Northern interchange design changes October 2010 – see box A on main map overleaf

Southern interchange design changes October 2010 – see box C on main map at right

Banora Point upgrade refinements to the design

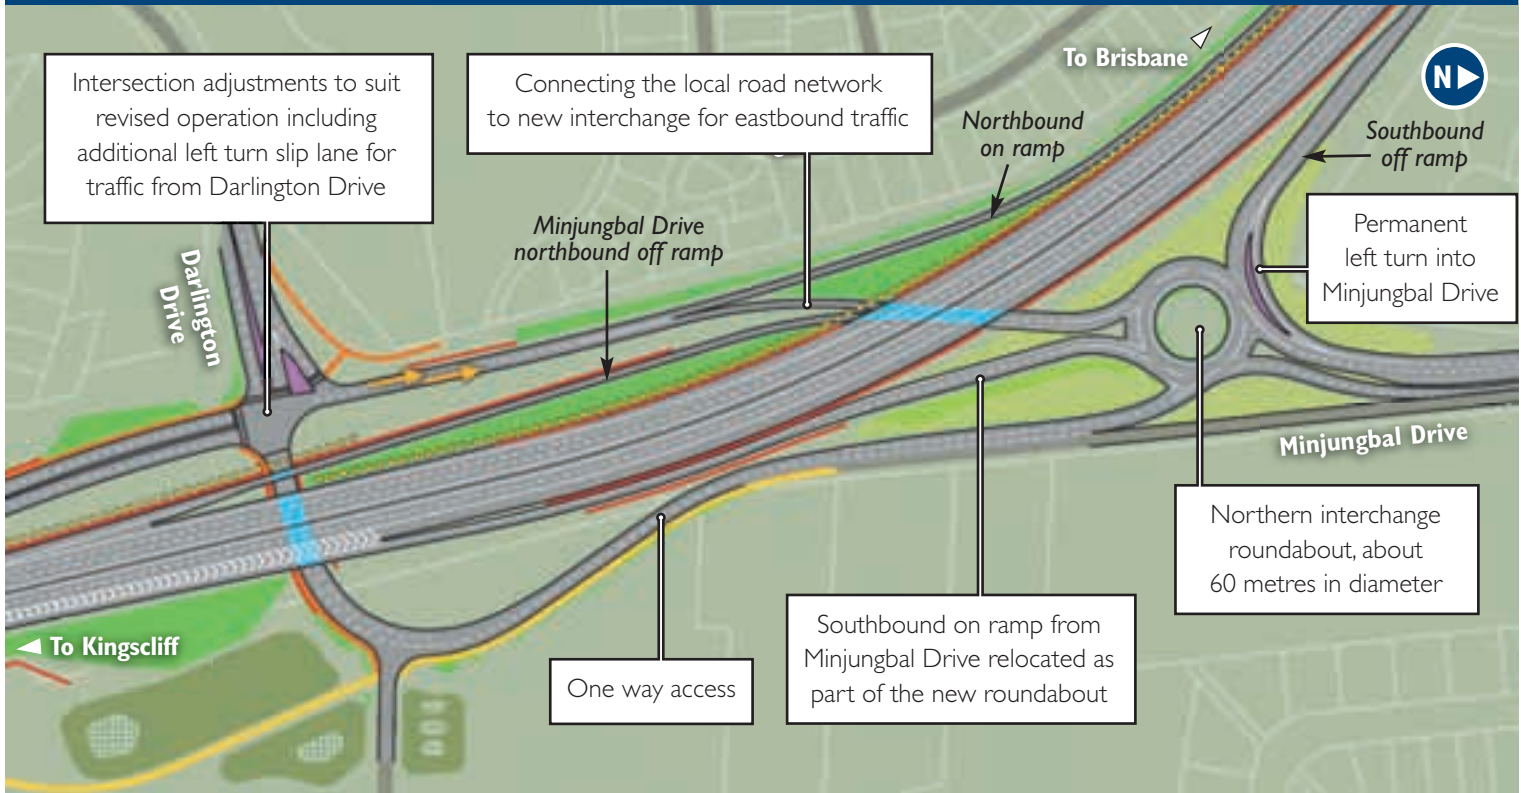
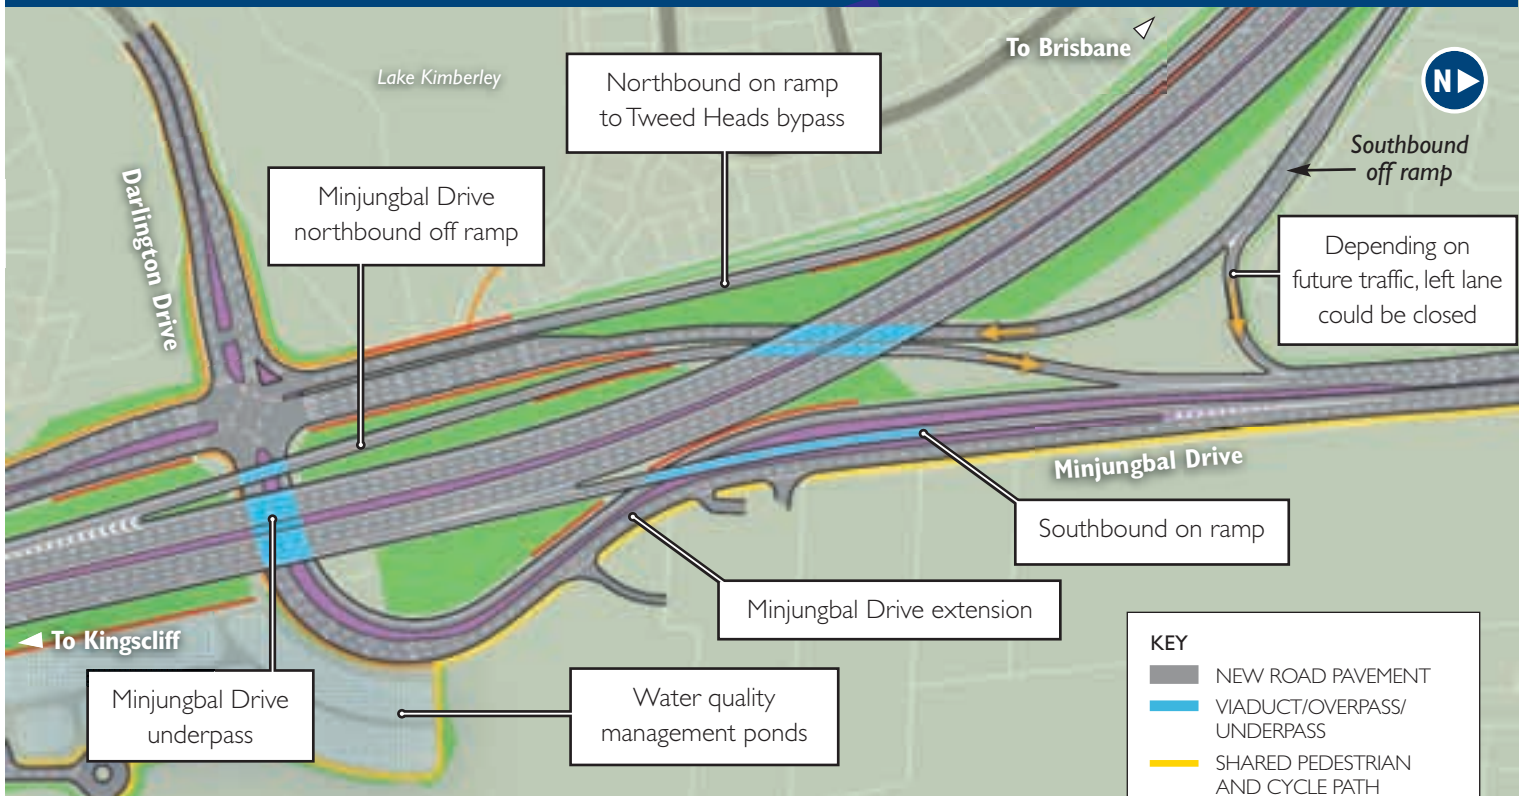
Beneficial changes to the northern interchange

Changes to the design of the northern interchange are shown alongside the proposal displayed in February 2008. The changes:

- Have similar traffic performance objectives.
- Minimise disruption to the local community and businesses during construction.
- Improve access to Shallow Bay Drive.
- Improve urban design at the entry to Minjungbal Drive.
- Improve functionality of the interchange through the provision of a U-turn at the roundabout.
- Provide a permanent left turn lane from the southbound off ramp into Minjungbal Drive.

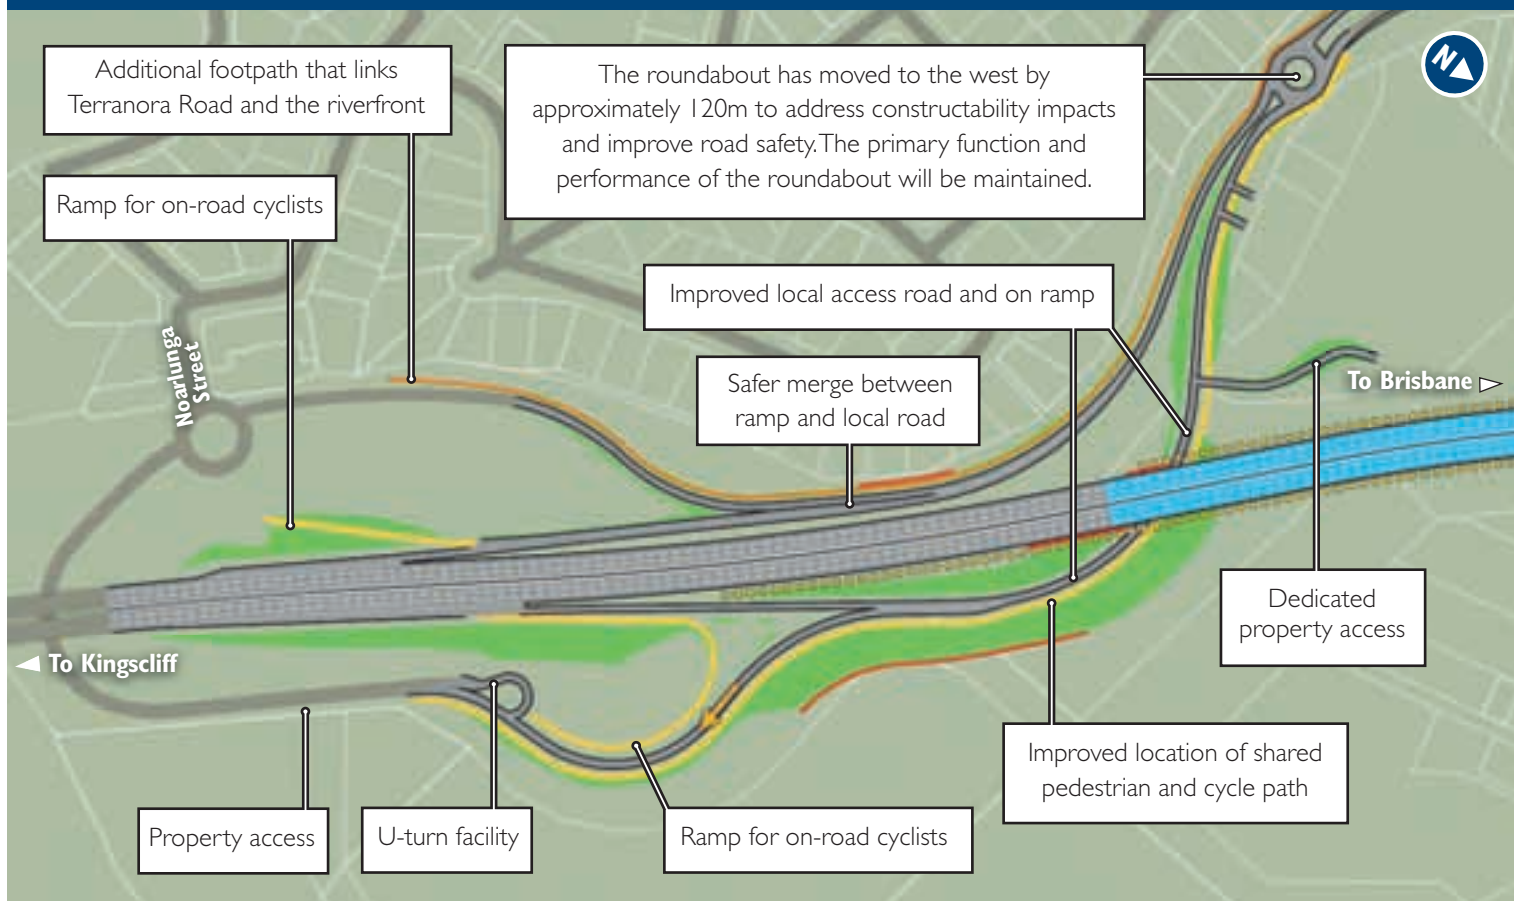
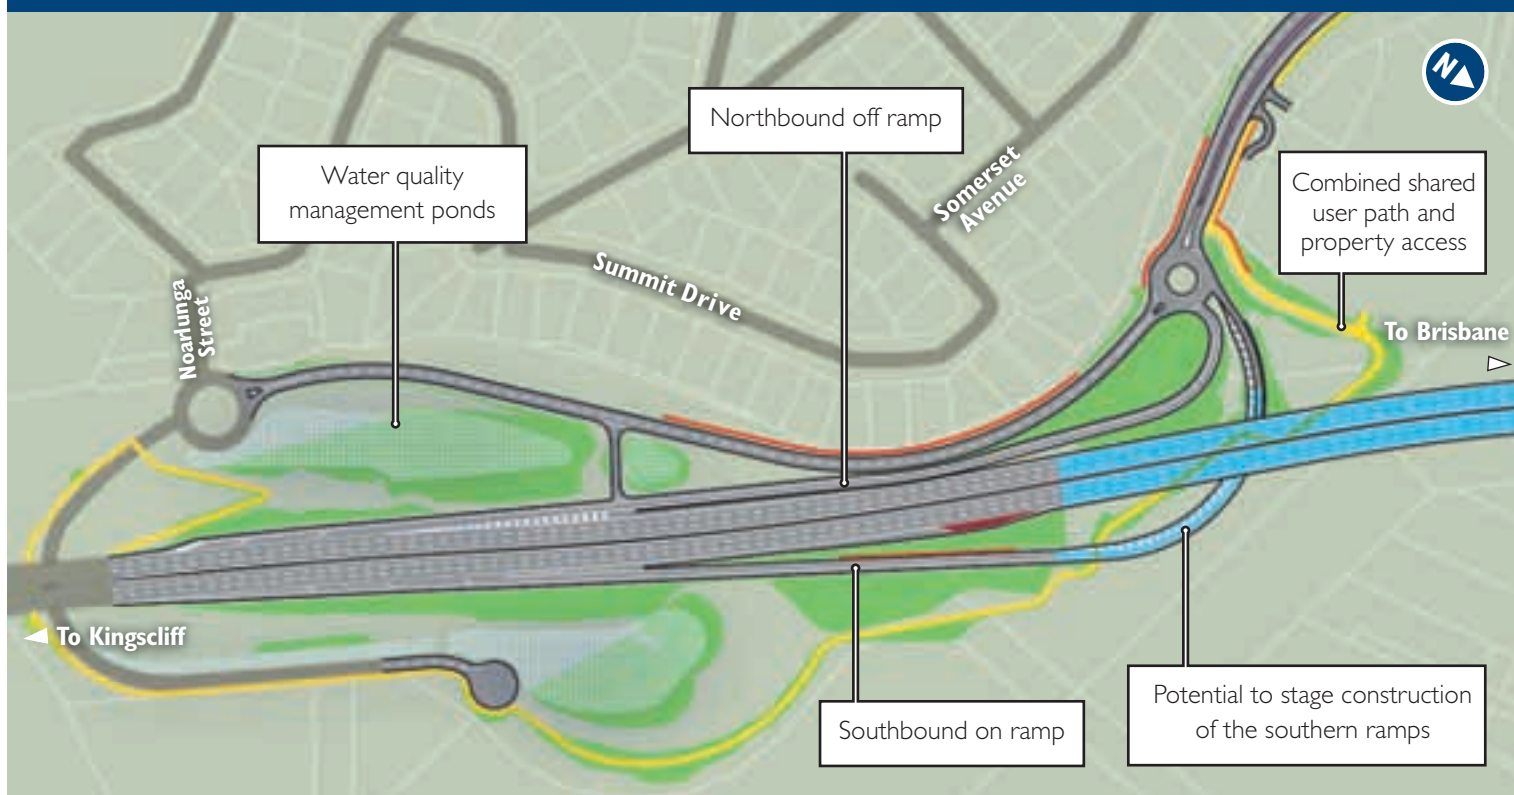
Beneficial changes to the southern interchange

Changes to the design of the southern interchange are shown alongside the proposal displayed in February 2008. The changes:

- Are a more functional layout to suit the narrow highway corridor.
- Deliver the ultimate southern interchange instead of a staged delivery that was an option in the environmental assessment.
- Mean a smaller footprint at the southern interchange, resulting in reduced impacts on heritage walls, the existing cutting and retaining walls.
- Reduce construction impacts by relocating the roundabout approximately 120 metres to the west. The new location will maintain the same level access and traffic performance.
